**PLANNED UNIT DEVELOPMENT
& SUBDIVISION STAFF REPORT****Date: June 21, 2007**

DEVELOPMENT NAME Northside, Ltd

SUBDIVISION NAME American Red Cross Subdivision

CONTEMPLATED USE Planned Unit Development approval to allow shared access between two building sites, and Subdivision approval to create three legal lots from three metes and bounds parcels.

SITE PLAN

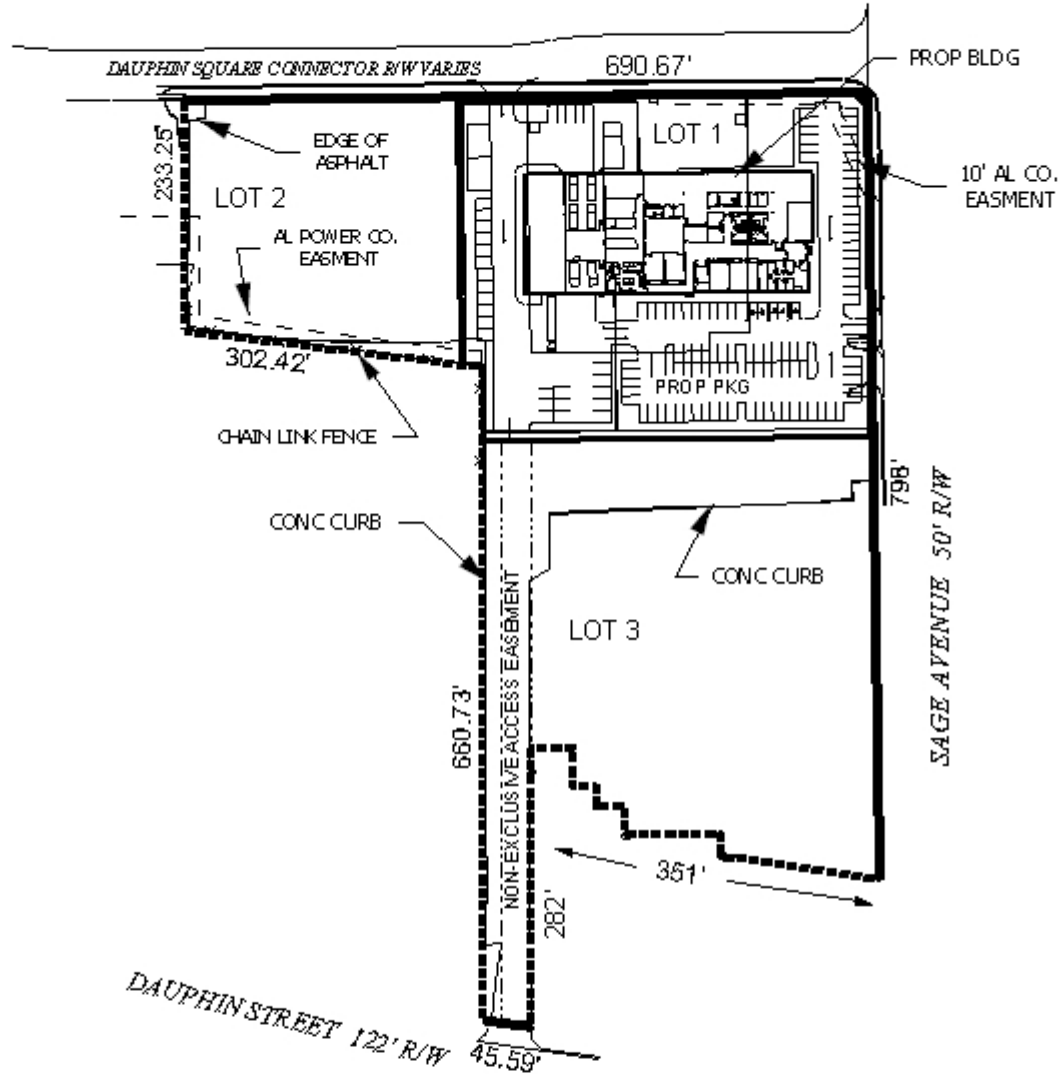
The site illustrates the proposed building, and parking spaces; however, waste receptacles, such as a dumpster, are not reflected on the site plan, nor are any trees or landscaped areas: the site must be brought into compliance with the Zoning Ordinance, including the provision of trees and landscaping.

- 1) the placement of a note on the Final Plat stating the development be limited to one curb-cut onto the Dauphin Street, two curb cuts to North Sage Avenue and two curb cuts to Dauphin Square Connector, with the size, design and location to be approved by Traffic Engineering, and conform to AASHTO standards; and
- 2) the placement of the 25-foot building setbacks on the Final Plat.
